POWER PLANT - GENERAL SERVICES HARNESS (LOOM E) - DELETION OF CLIP NUT AT CP7847 -
CATEGORY CODE 7 - MOD.ENG-71-0205

V2500-ENG-71-0205

SERVICE BULLETIN

Diagrammatic view on loom E showing position of clip point 7847
Fig.1

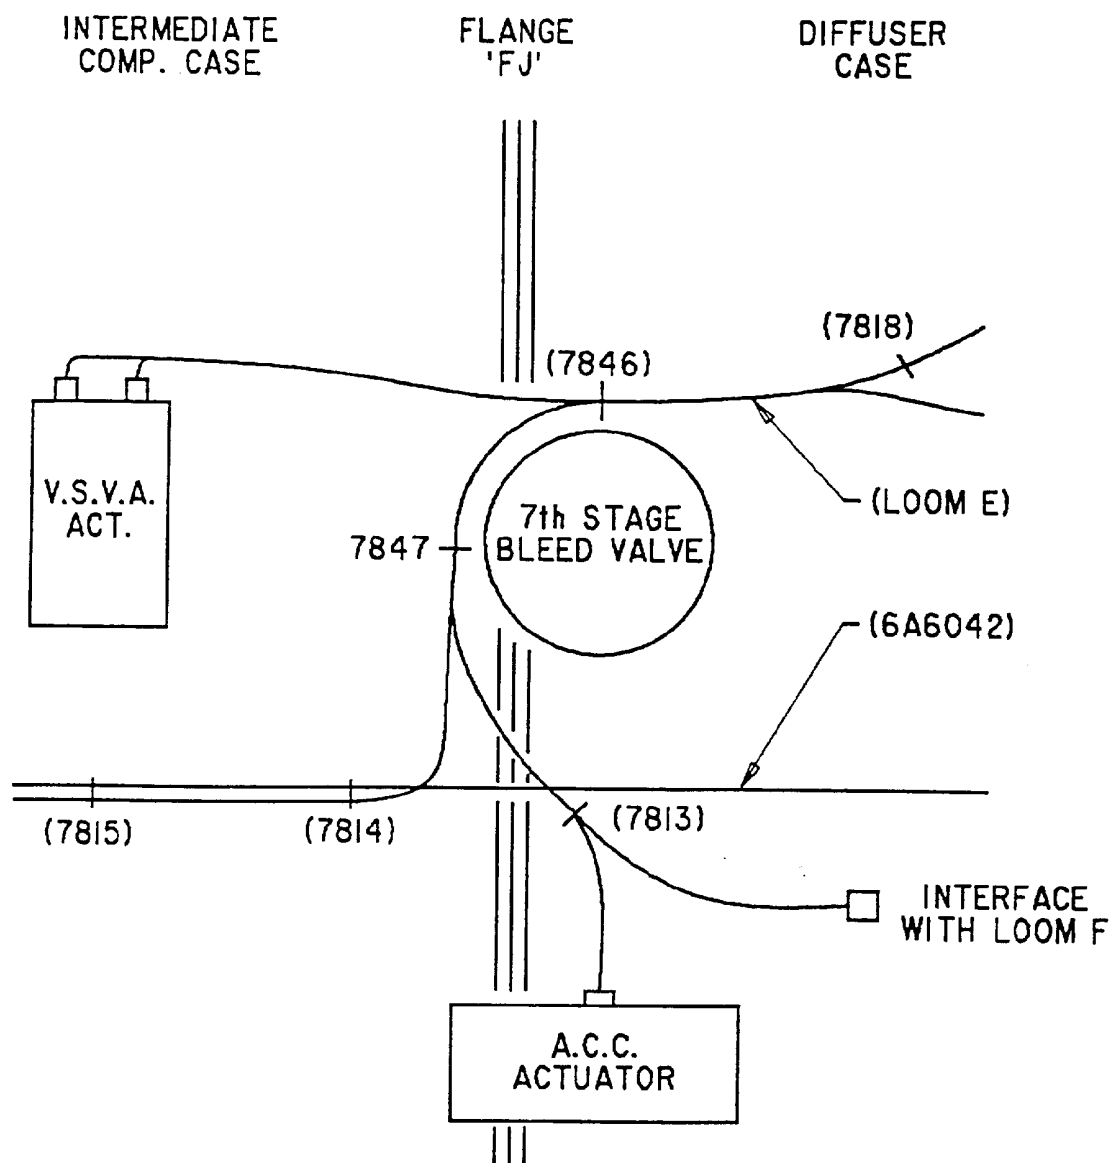
Assembly of the clipping point CP7847 of the harness loom 'E' can be difficult.

The problem is caused by unsatisfactory access to the bolt head in this area.

- (a) Clipping point CP7847 has been changed. The clip nut has been replaced with a standard nut. In addition, the position of the bolt and nut has been moved through 180 degrees.

Clipping point 7847 after alteration
Fig.2

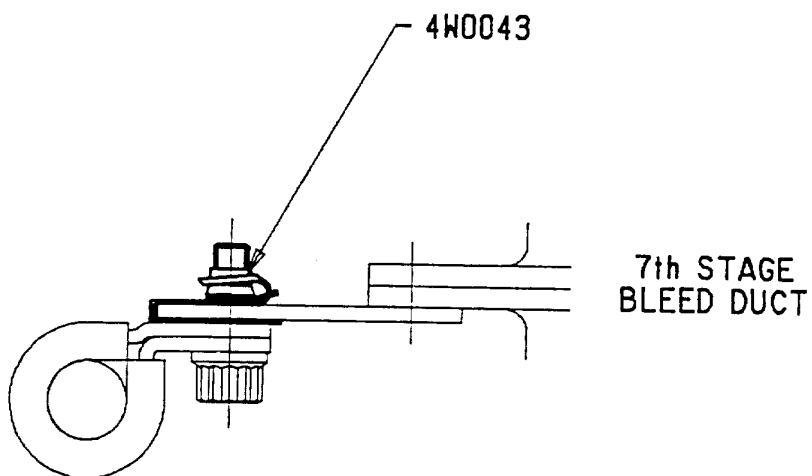
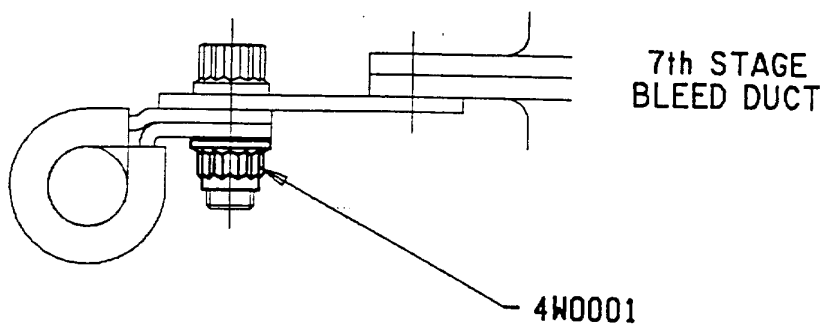
CLIPPING POINT 7847
BEFORE ALTERATION

New Part No. (ATA No.)	Qty	Est'd Unit Price (\$)	Keyword	Old Part No. (IPC No.)	Instructions Disposition
4W0001 (71-52-51)	1	2.67	Nut, self locking dbl hex (0.190 dia)(CP7847)	4W0043 (01-072)	(A)(S1)(1D)
